UNITED STATES PATENT AND TRADEMARK OFFICE

10/502,028

Office Action Summary	Application No. 10/502,028	Applicant(s) HEATHCOTE, IAN	
	Examiner Thomas Diaz	Art Unit 4171

DETAILED ACTION

Figure i- Copending application figure.

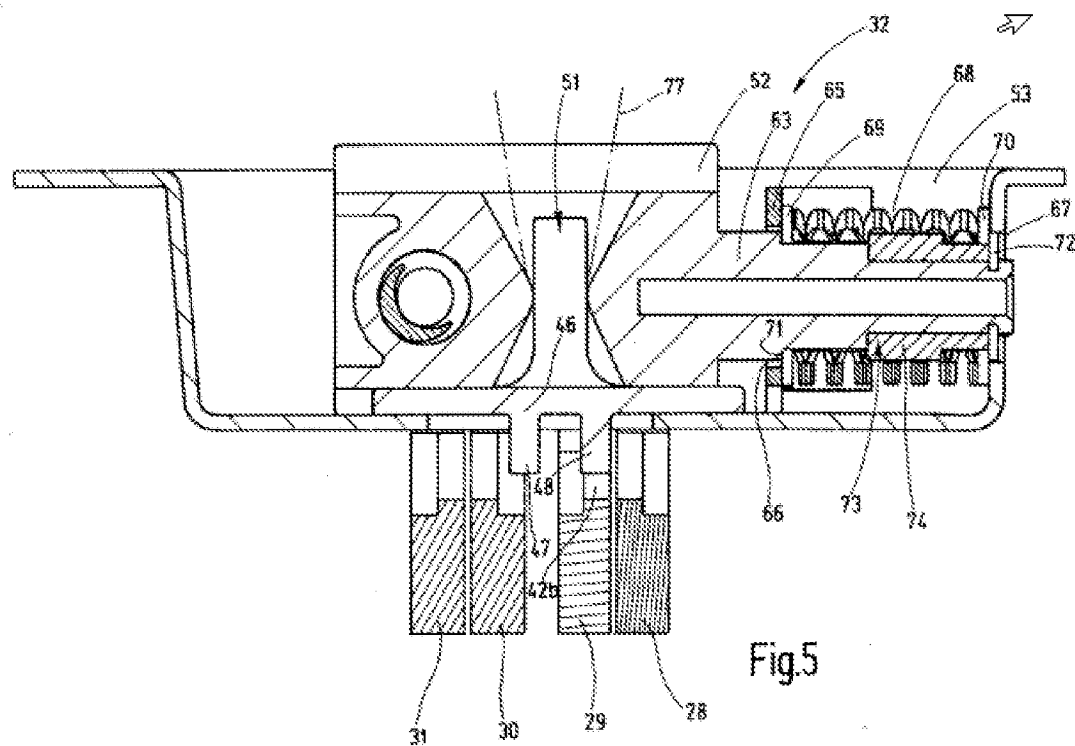
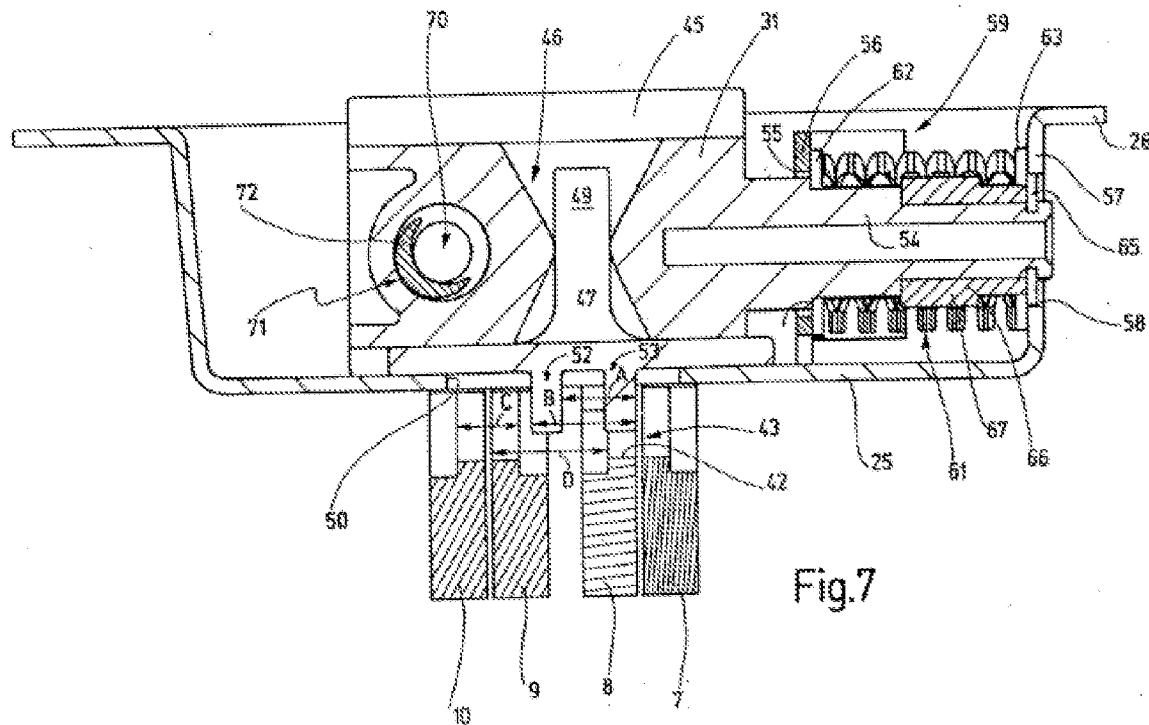
identical, they are not patentably distinct from each other because the conflicting claims are directed towards a gear shifting mechanism which as interpreted by the examiner includes most of the features and structure of the gear shifting cassette unit claimed in the current application.

For example, claims 1,6,7 of the current application are directed to a gear shifting cassette unit which comprises a housing, a traversing member and a coupling. This is clearly recited in the copending application claims in which the applicant claims a shift selector element corresponding to the coupling and a support which holds the selector element along with other analogous structure to the gear shifting cassette such as a pressure spring, blocking element, and shift rails. The copending application make no mention of a housing, however, it would be obvious that such a structure would have a housing and also read in light of the specification it is clear that the inventions are appear identical in structure.

Claims 17, and 18 of the current application are directed towards a blocking member for blocking the non-selected shift rails from moving which corresponds to the blocking element discussed in claims 13,14, and 15 of the copending application, which also performs the same function.

Claims 21-24 of the current application are directed towards shift elements and distances between the shift elements and the shift rails and how the shift elements engage the shift rails. Similar structure and relationships of distances are claimed throughout claims 1-8 of the copending application.

Claim 26 of the current application is directly claiming a gear shifting mechanism comprising at least two shift rails which have a shift rail connecting member and a cassette unit. As discussed above, a lot of analogous structure of this cassette unit is claimed in the copending application along with the shift rails and shift selector elements throughout the claims, in particular, claims 1,13,15,16,17,18, and 19.

Figure iii- Willford et al.'s device.

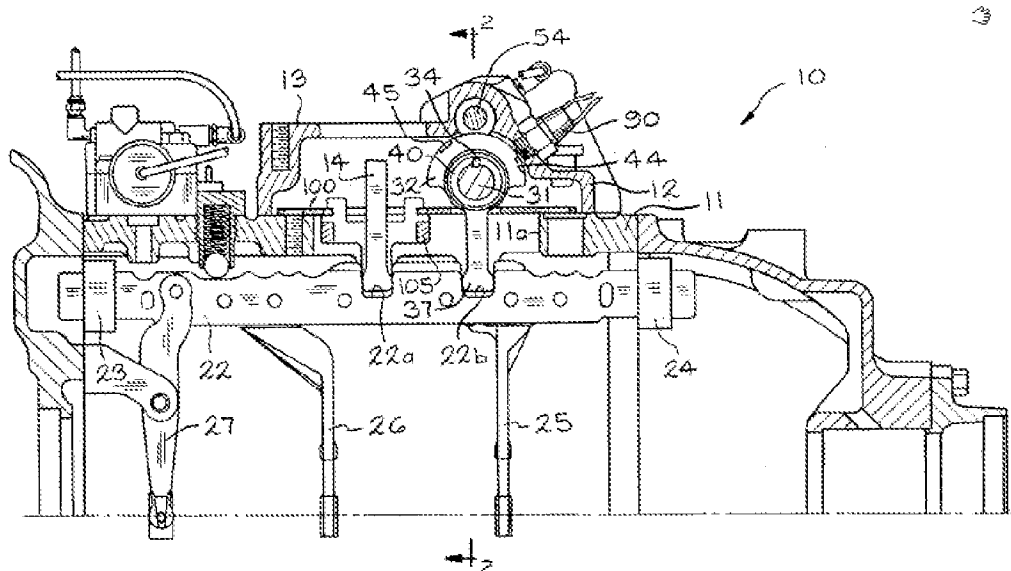
- a gear shifting cassette unit corresponding to the structure contained within the shift housing (fig. 1, 13) which is capable of operating in a transmission comprising at least two shift rails,
- a cassette housing corresponding to the housing disclosed in the prior art (fig.1, 12 and 13),
- a bearing means which corresponds to either a shaft element (fig.1, 31) or piston element (fig.2, 51 or 50) which both are capable of movably supporting at least one shift element which engages shift rails,
- said cassette housing comprising a coupling which corresponds to either flange element (fig.2, 43) or snap ring (fig.2, 42), which are used to connect a shifting element to a shift finger.

The applicant recites a 112th sixth paragraph limitation by reciting a "mounting means for fixedly securing the housing on a transmission housing..." The applicant discloses a flange on the cassette unit housing as the fastening means. The restraining plate (fig. 1, 100) acts as an equivalent to the mounting means disclosed by applicant for fixedly securing the respective housings together.

The applicant claims said coupling from claim 1 being provided on a carrier member. The carrier member corresponds to the shaft element (fig.1, 31). It is understood that this shaft element could also act as a bearing element as described in claim 1.

Applicant claims a gear shifting mechanism (fig. 1) comprising at least two shift rails and a cassette unit. The shift rails have a connecting member and can be moved out of a neutral position to engage a gear. The prior art teaches at least two shift rails (fig.2, 20 and 21) which can be moved out of a neutral

Figure iv- Willford et al.'s device.

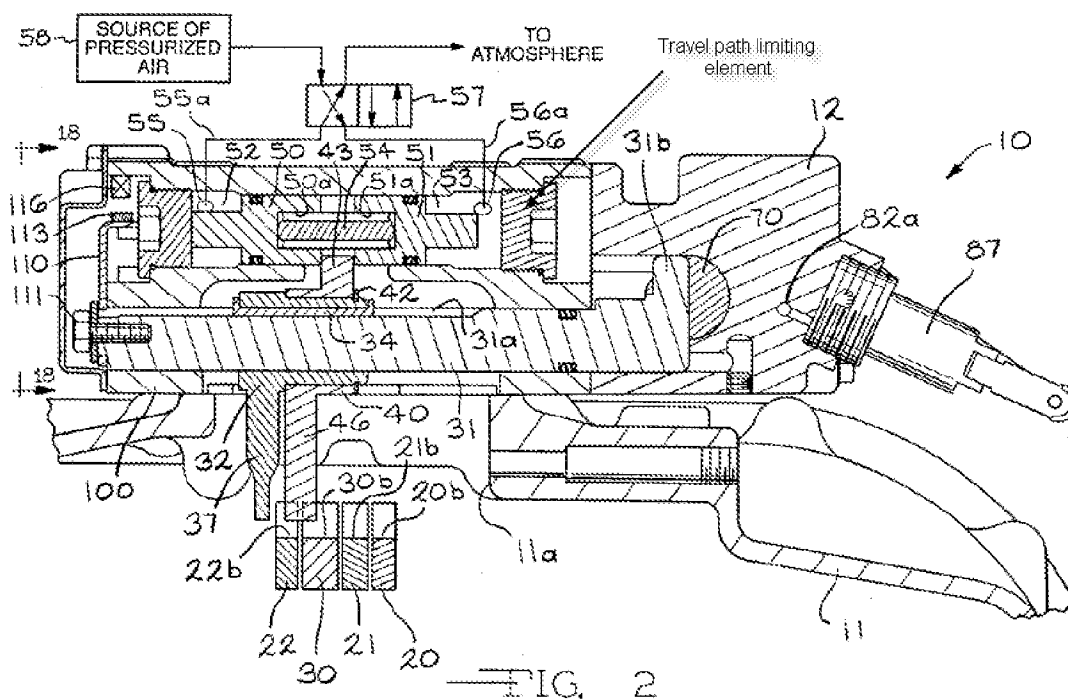
The applicant claims a shift element which corresponds to shift member (fig.2, 32), which protrudes through an opening in the housing for engaging the shift rails.

The applicant claims said bearing means from claim 1 comprising a traversing member which corresponds to the piston element (fig.2, 50 or 51) located in the cassette housing and which supports a carrier member (fig.2, 43). This carrier member is part of the manual shift element and could also correspond to the coupling member.

The applicant claims said traversing member comprising two opposite guiding surfaces which correspond to the two opposite surfaces of the piston element (fig.2, 51) which are in sliding engagement with inner surfaces of the casing facing each other.

The applicant claims a travel path limiting element being associated with a traversing member which corresponds to the structure labeled by the examiner in figure 2. This structure limits the before said traversing member (fig.2, 51 or 50) from moving laterally more than a certain distance.

Applicant claims two shift elements having the shape of tongues which extend into the shift rails and are spaced apart from each other. These shift elements correspond to the shift elements of the prior art (fig.2, 37 and 46) which have the shape of tongues and extend into the shift rails and are also spaced apart from each other.

The prior art teaches a gear shifting mechanism which an actuation unit seen in figure 2 and figure 4 with which has a housing (fig.2, 12) mounted on the transmission housing. The actuation unit comprises a shift finger (fig. 2, 37 or 46). This shift finger is capable of moving in both axial directions in order to both select a shift rail and move a shift rail as explained in detail in the prior art.

Figure v- Willford et al.'s device.

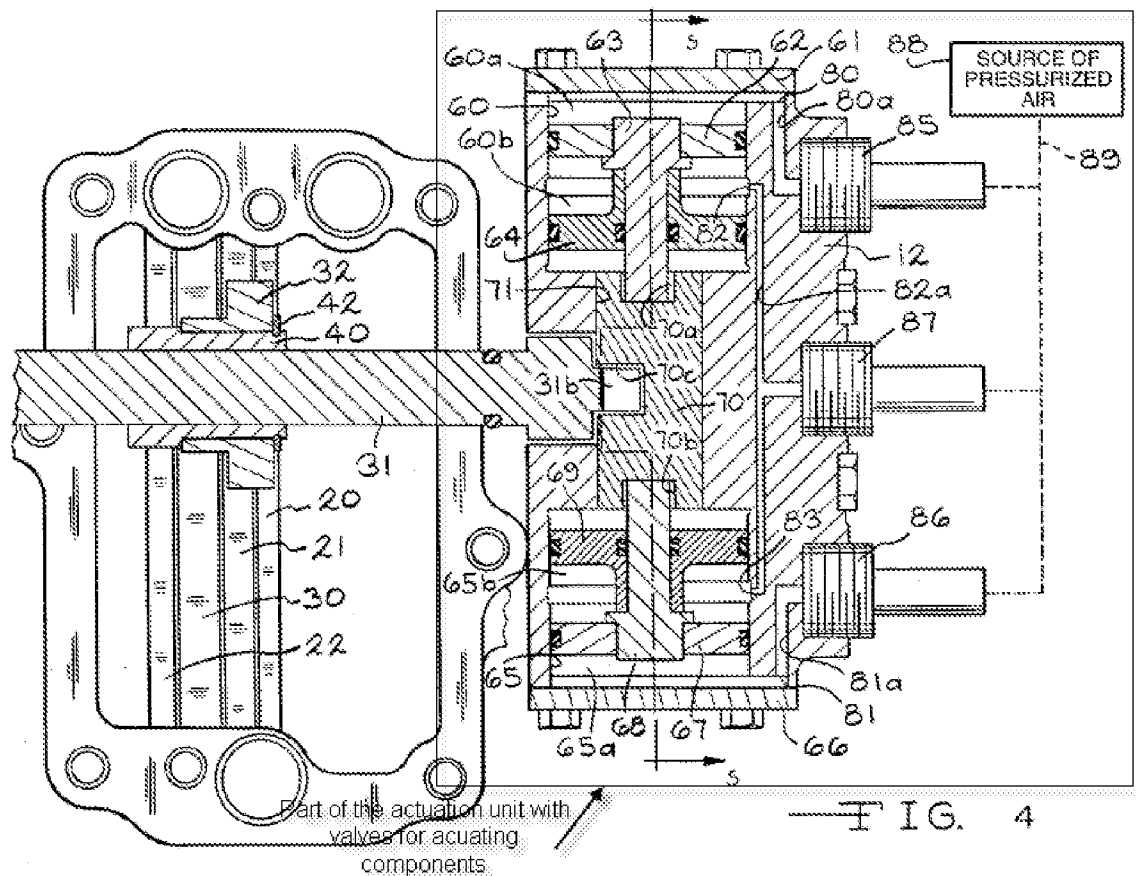
- a carrier member corresponding to the element (fig.2, 43) which is supported by the traversing member and being provided with the shift elements (fig. 2, 32 and 40). These shift elements protrude through an opening the casing as depicted in fig. 1 and fig. 2. The carrier member has a coupling as discussed above corresponding to the element (fig.2, 42) which connects the carrier member to the shift finger (fig.2, 37).

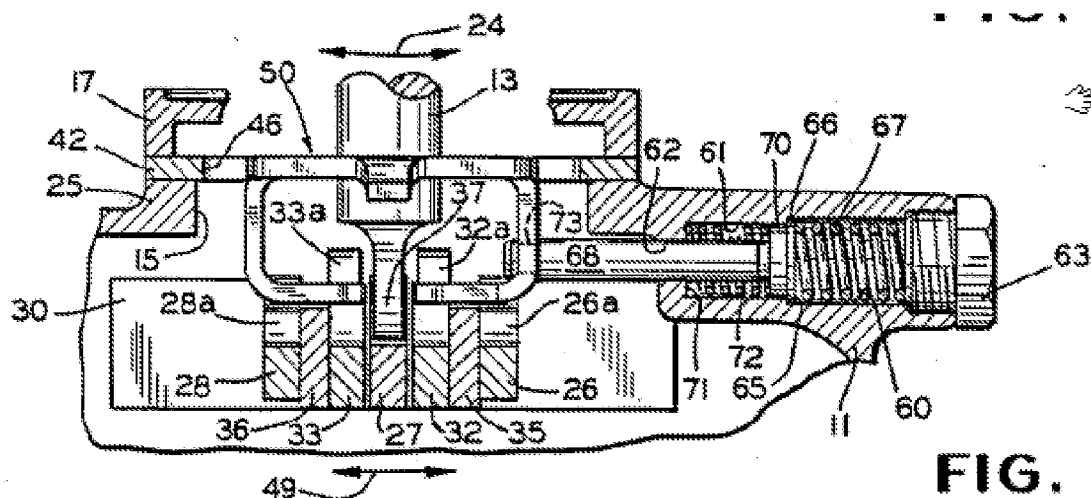
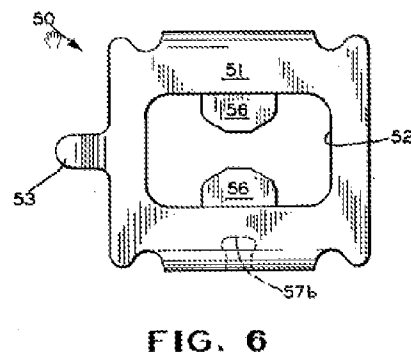
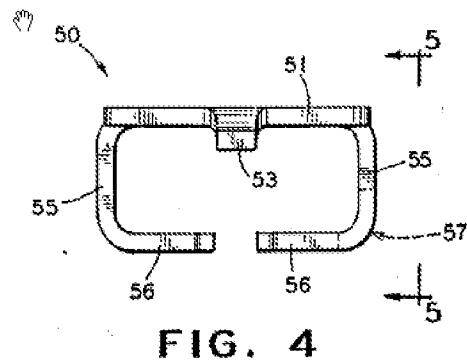
Applicant claims a traversing member comprising a blocking member for blocking the movement of all non-selected shift rails. Meyers et al. discloses end portions (fig.4, 56) of the interlocking bracket which prevent the movement of shift rails depending on the selection made (col.6, lines 42-48).

Applicant claims the blocking member comprising at least one cutout for unblocking the shift rail being selected. Meyers et al. teaches a cut out as depicted in both figure 3 and figure 4 through which the shift finger engages the shift rail being selected.

Applicant claims that the blocking member is a one piece unit with the traversing member. Meyers et al. teaches as depicted in figure 4 that the interlocking bracket (traversing member) is a one piece unit with the end portions (blocking members).

Figure vi- Okubo et al.'s figure.

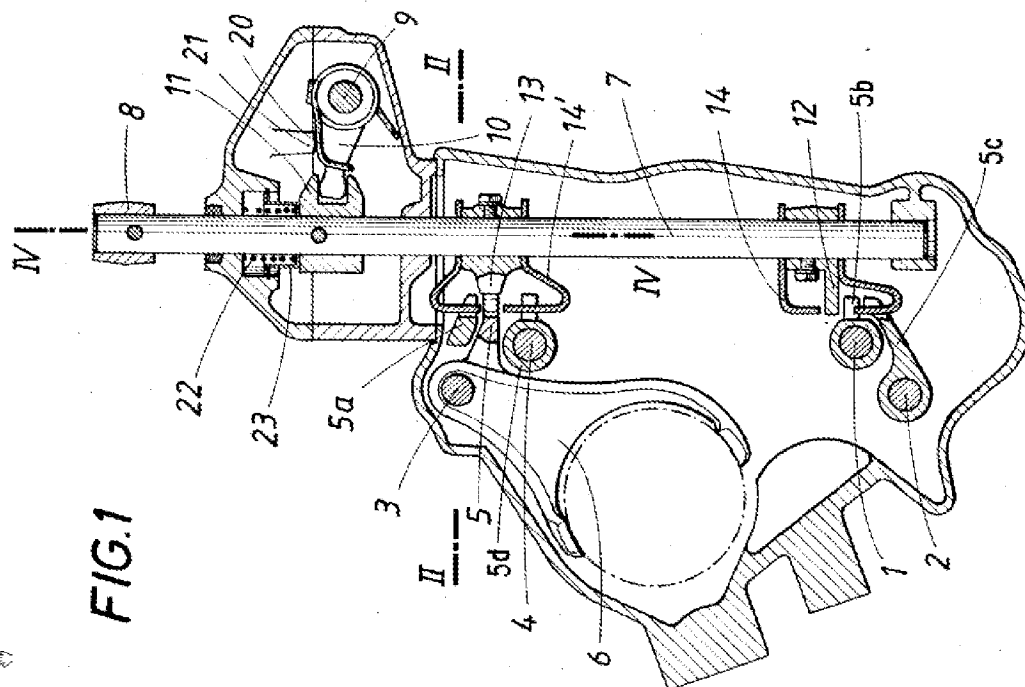
Okubo et al. teaches the shift rails (fig.1, 1,2,3,4) and the shift fingers (fig.1, 12 and 13) which engage the connecting elements of these shift rails.

Okubo et al. teaches the distance between the tongues or shift fingers being greater than the width of the connecting elements of the shift rails (fig.1, 5a) for the purpose of providing a multi-step speed changing operation.

Okubo et al. teaches the shift rail (fig.1, 4) being in between the tongues (fig.1, 13 and 12) where only one of the tongues is selecting a shift rail for the purpose of providing simple construction between the gear shift shaft, gear shift rods and clutch. (col.4, lines 65+ and col.5, lines 1-7).
